PEACH BOTTOM ATOMIC POWER STATION, UNIT NO. 2

AMENDMENT TO FACILITY OPERATING LICENSE

Amendment No. 108
License No. DPR-44

ATTACHMENT TO LICENSE AMENDMENT NO.108

FIGURE 3.5K2 MCPR OPERATING LIMIT vs T

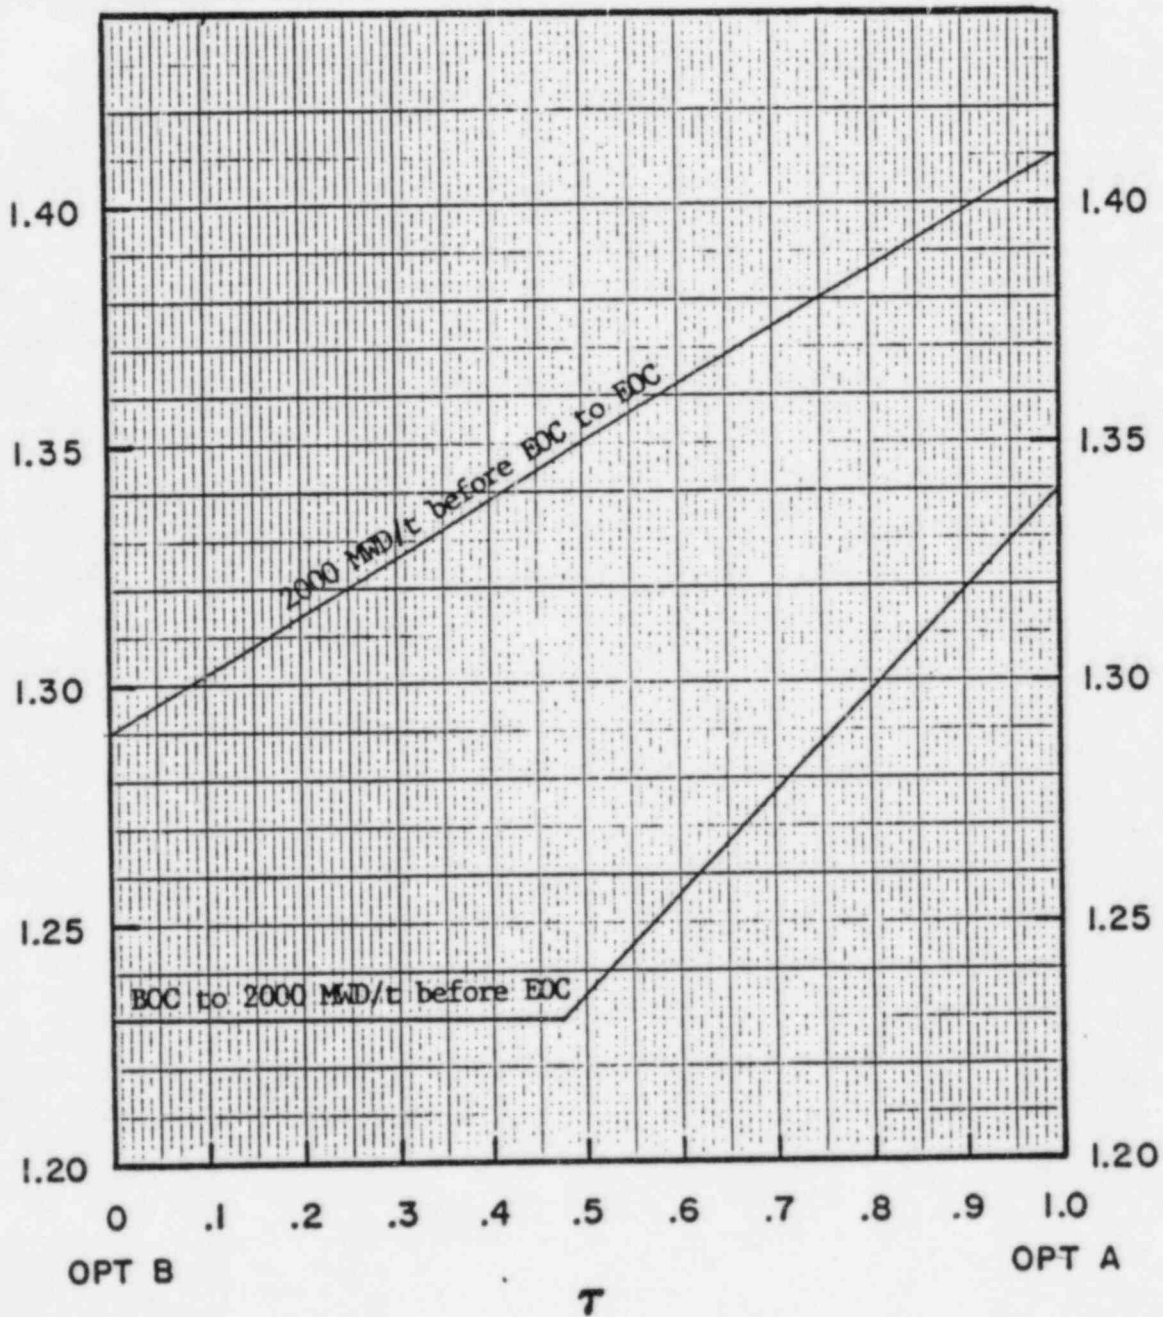
FUEL TYPE P8X8R*

* Applicable to all P8X8R fuel bundles including BP8X8R and the P8DRB285 (Reload 5) Types

FIGURE 3.5.1J MAXIMUM AVERAGE PLANAR LINEAR HEAT GENERATION RATE VERSUS PLANAR AVERAGE EXPOSURE

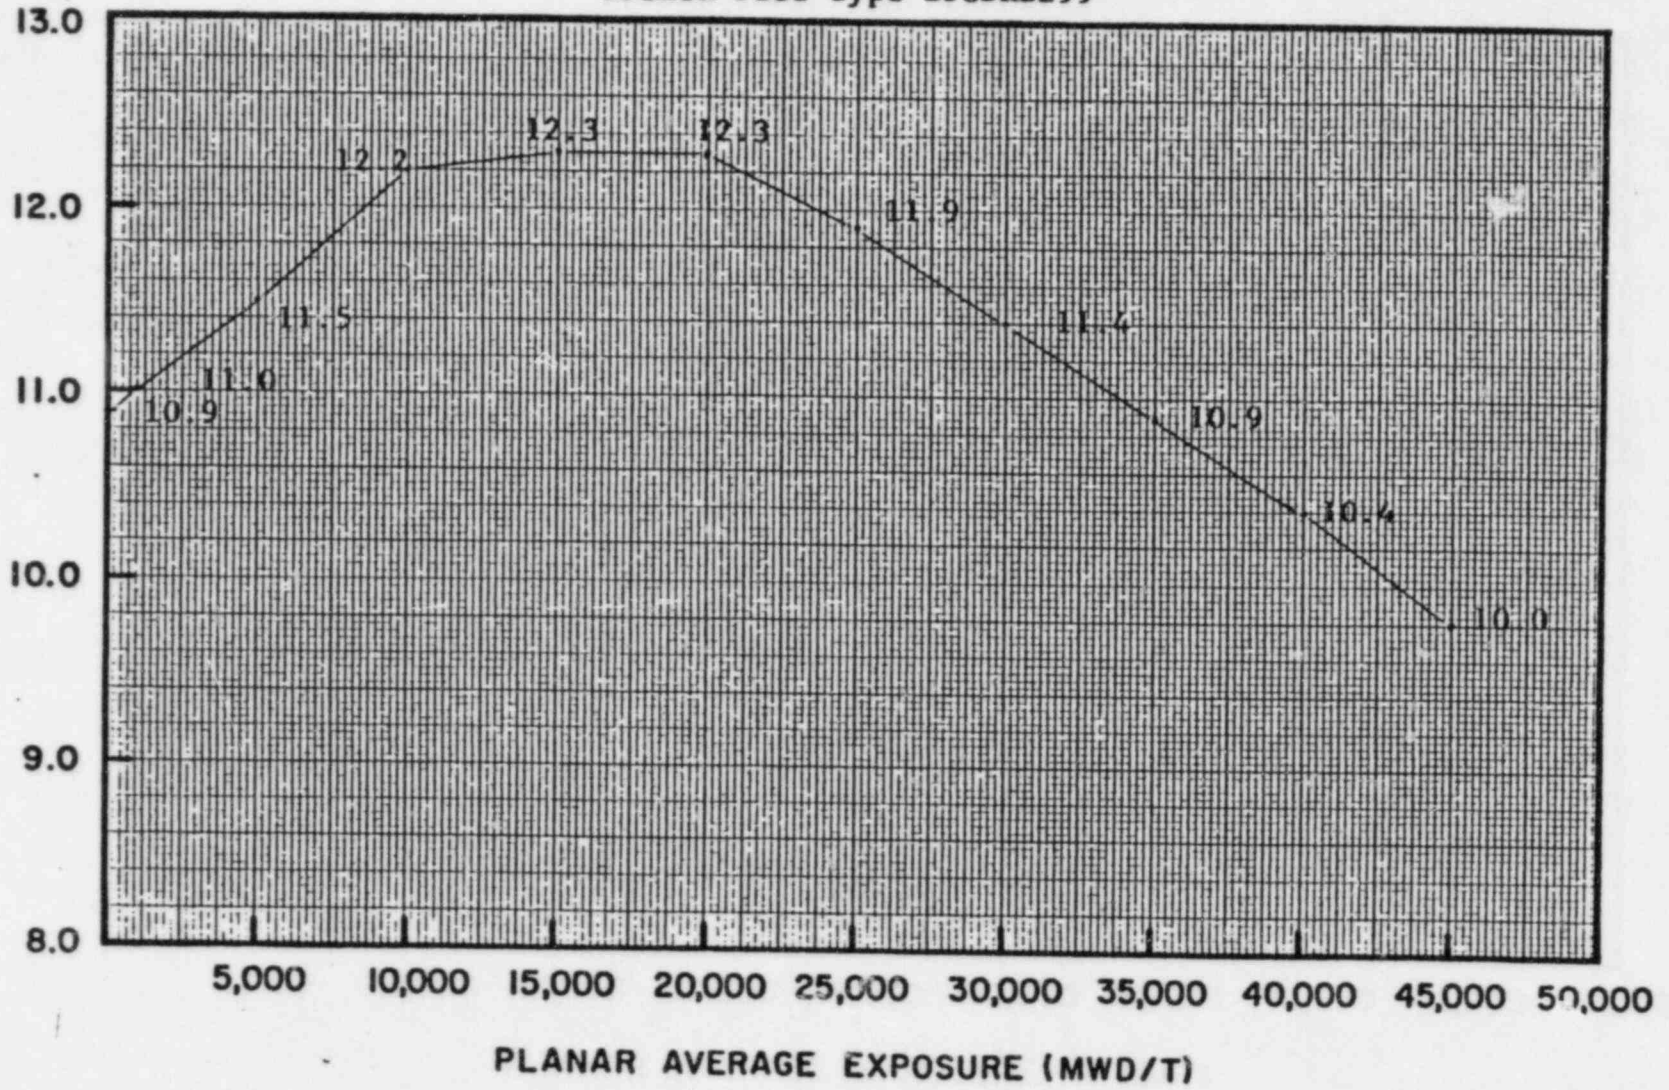
FUEL TYPE P8DRB299

BP8X8R Fuel Type BP8DRB299

FIGURE 3.5.1.1. MAXIMUM AVERAGE PLANAR LINEAR HEAT GENERATION RATE VERSUS PLANAR AVERAGE EXPOSURE

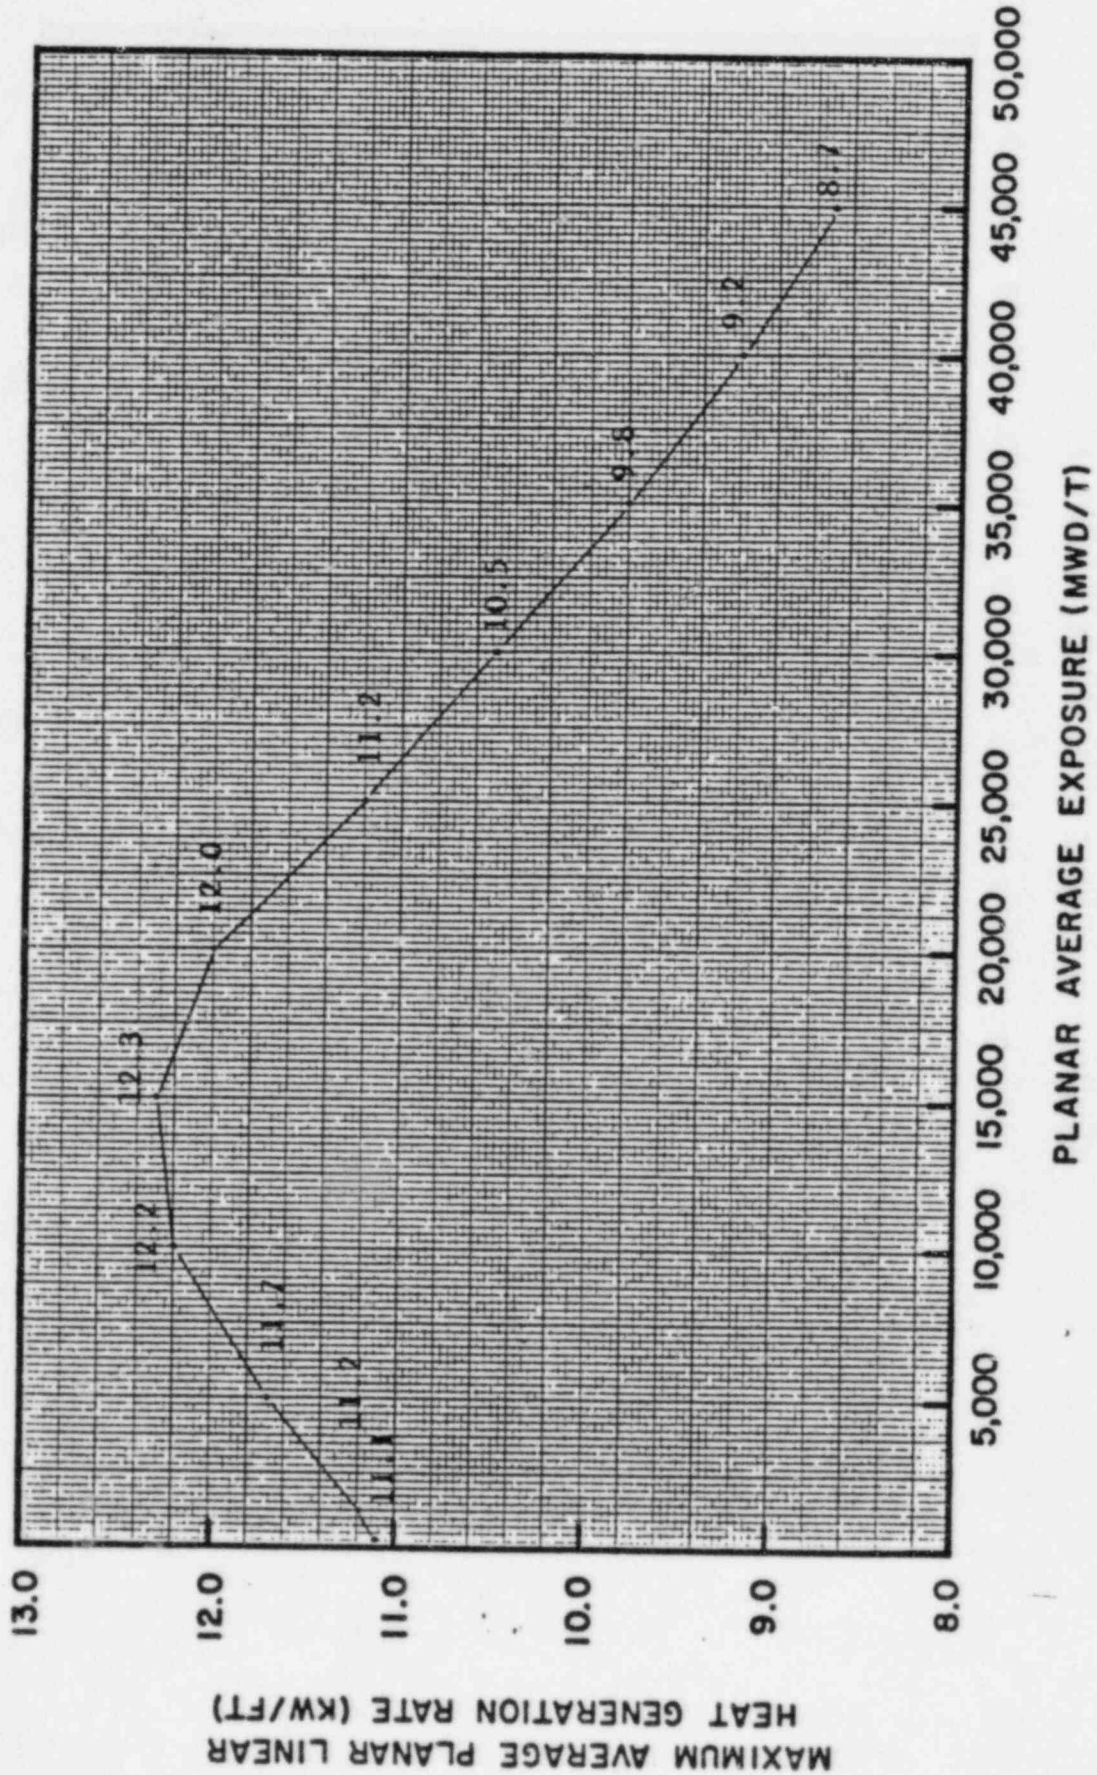
FUEL TYPE BP8DRB299H
